**RE: North Eveleigh Affordable Housing (SSD Reference: SSD5708)  
Response to City of Sydney Council's Comments and Submission of Amended  
Architectural Drawings**

This letter is prepared on behalf of City West Housing, the Applicant for the abovementioned development application. The purpose of this letter is to describe proposed amendments to the scheme, following additional consultation with the City of Sydney Council and further detailed design.

Figure 1 - Level 6 section

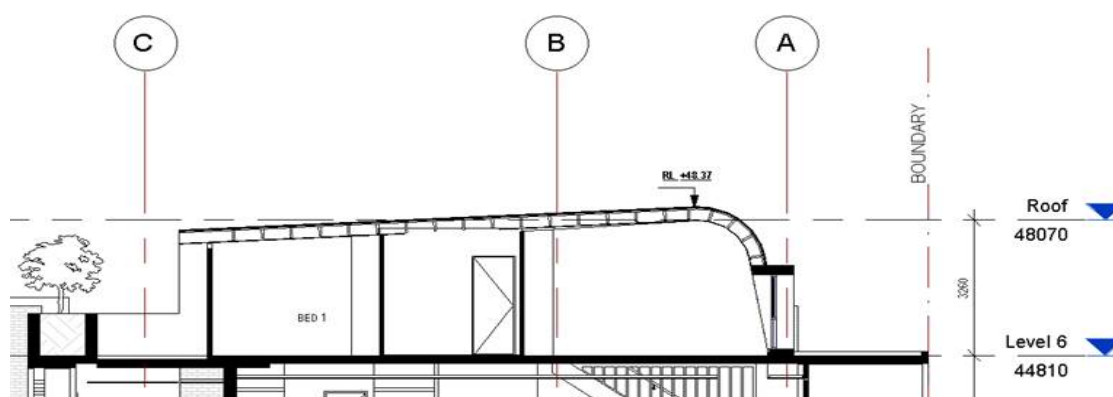
The proposed curved, mid-level roof element is proposed to be clad in zinc to reference industrial materials found in the area. As part of the detailed design process underway, it was identified that the proposed curve (1 degree at its flattest) does not work with the proposed material (which specifies a minimum slope of 3 degrees).

In order to achieve the slope, it is proposed to increase the height of the roof in this section (which is not the tallest part of the building) by approximately 40cm (refer to Figure 1). This outcome does not present any additional impacts and protects the 2.7m floor to ceiling heights for the affected apartments.

In order to maintain a minimum 2.7 metre floor to ceiling height at the southern bedroom, the maximum height of the zinc roof is increased by 430mm to RL 48.37. This will not project above the maximum building height, and is not considered to have any noticeable impact, given the extent of increased height occurs at a very minor and localised part of the roof.

Rather than change this material, which is integral to the design, it is proposed to increase the slope of this roof to meet the manufacturer's specifications for the material.

**OUTCOME:** *This modification is reflected on the amended architectural drawings submitted under separate cover.*
